SGML:RLJ
70-687

SUBJECT: EVALUATION OF UNION CARBIDE - TUXEDO'S REQUEST TO PERMIT URANIUM WASTE FORM PROCESS

URANIUM
FLOW CHART

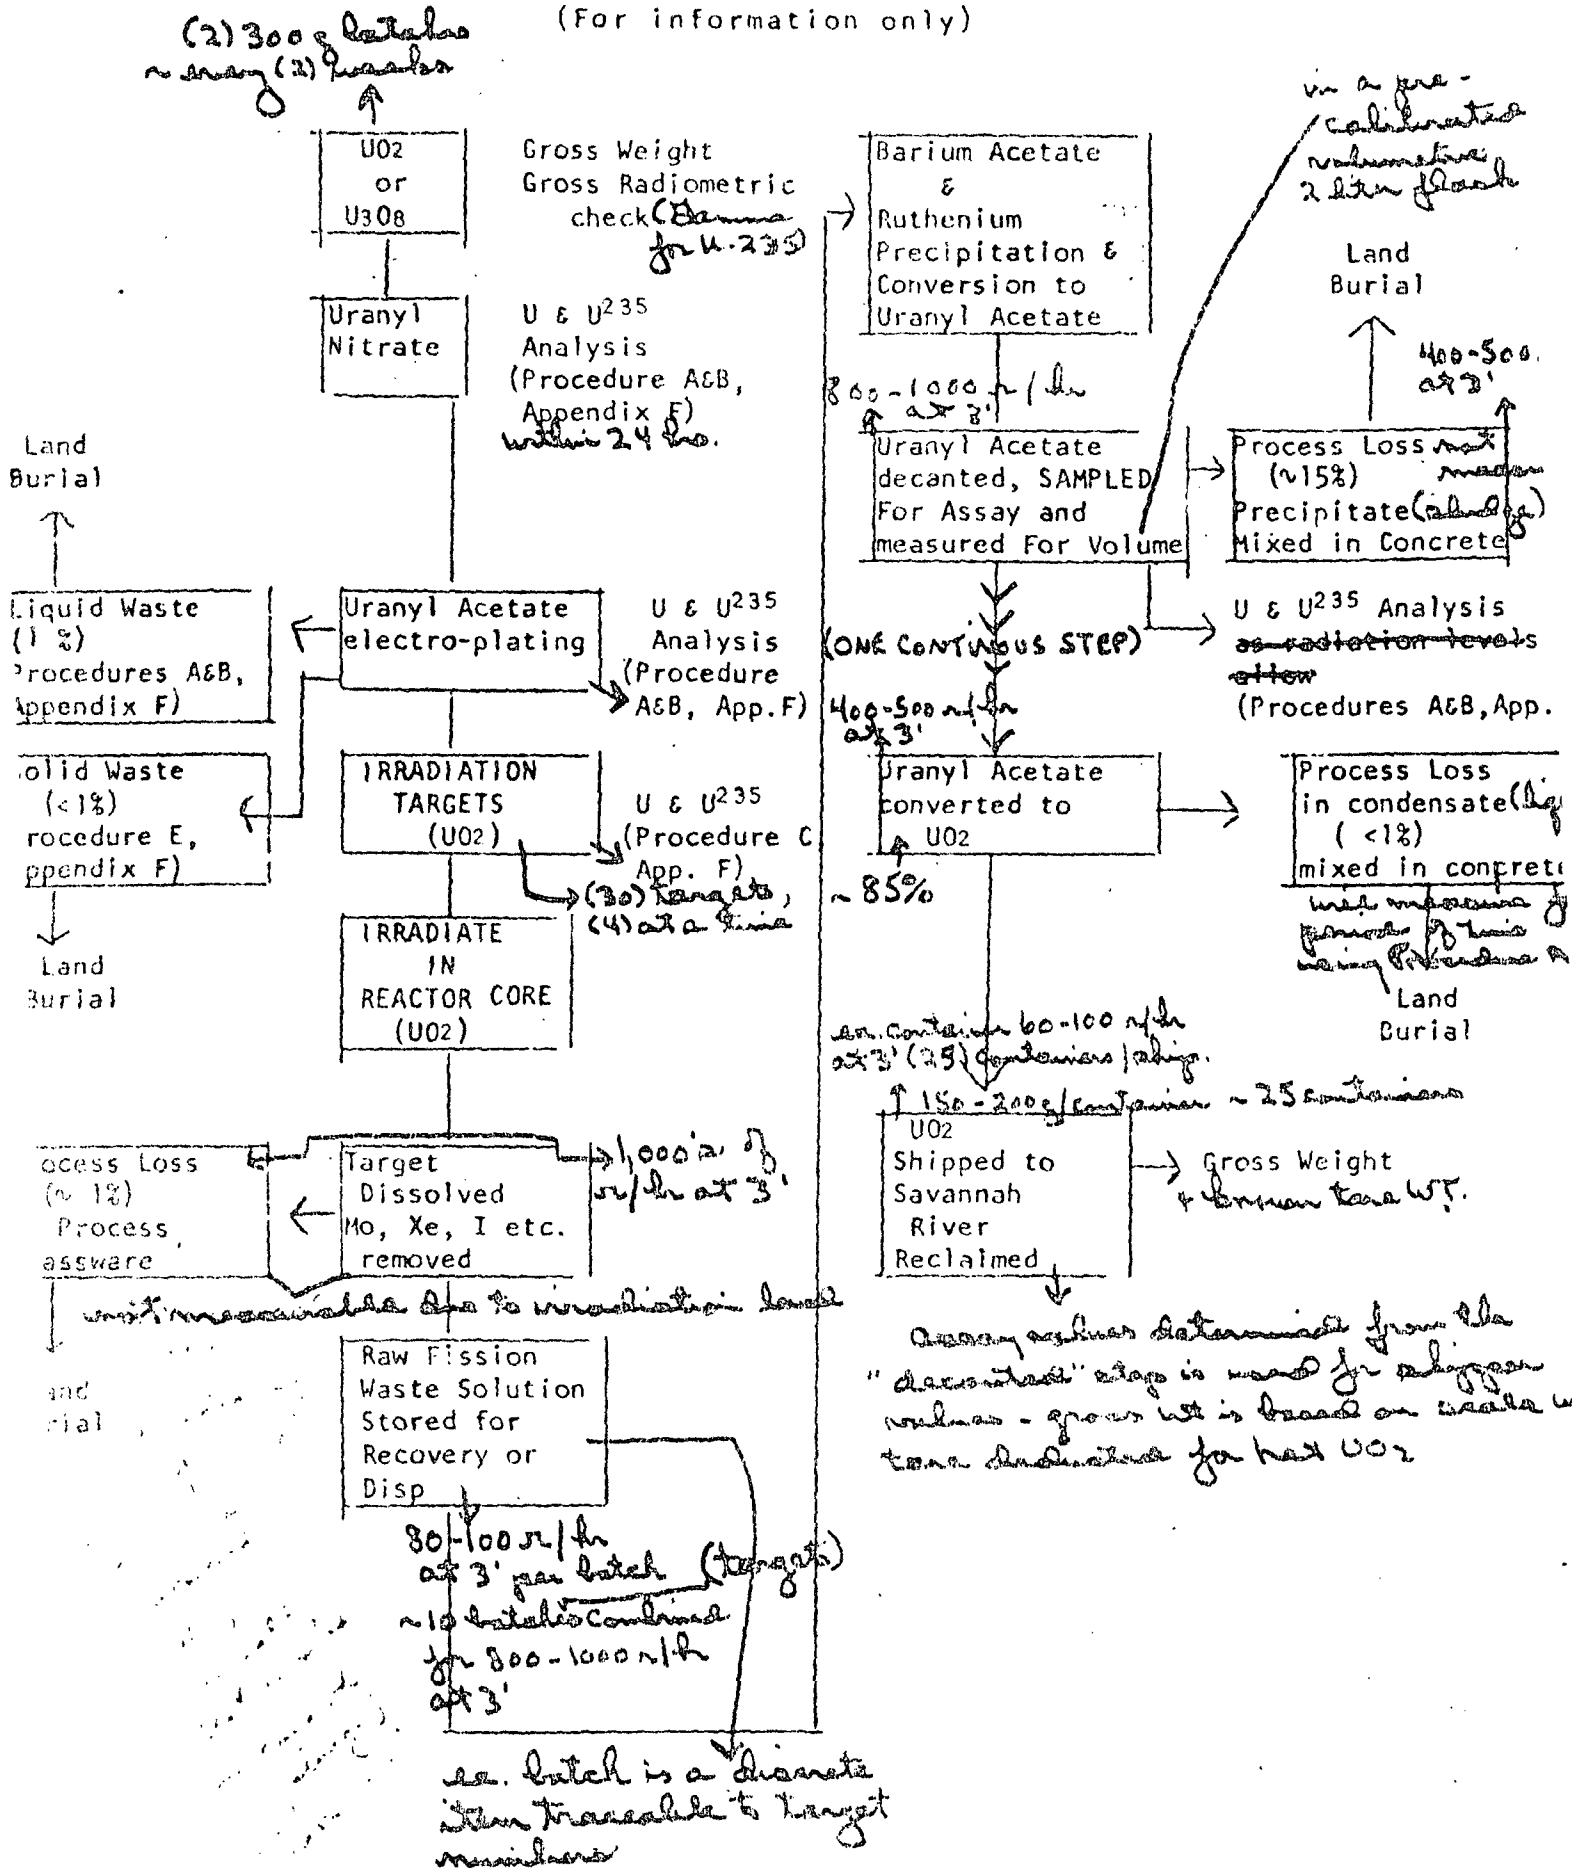
Figure A gives a brief overview of UC-Tuxedo's SNM operations while Figure B depicts the facility SNM flow and key measurement points. Figure B, as well as UC's revised FNMC Chapters 3, 4, and 7 were the primary sources for our review. Figure C and D provide descriptions of UC's Uranium Waste Form Process.

Union Carbide - Tuxedo has an SNM thruput of approximately 2 kilograms of highly enriched uranium per month. The measurement procedures portrayed on Figure B are considered adequate for the typical operations conducted and for the Uranium Waste Form Process. Procedures A thru E are described in detail in Appendix F of the FNMC Plan. Procedure A is the modified Davis - Gray method for determining total uranium, Procedure B is a NDA for non-irradiated U-235, Procedure C and D is NDA for irradiated U-235 and Procedure E is NDA for irradiated U-235 in waste drums. Note that once the SNM has been placed in the Reactor, the material becomes highly irradiated and stays as such throughout the remainder of the process.
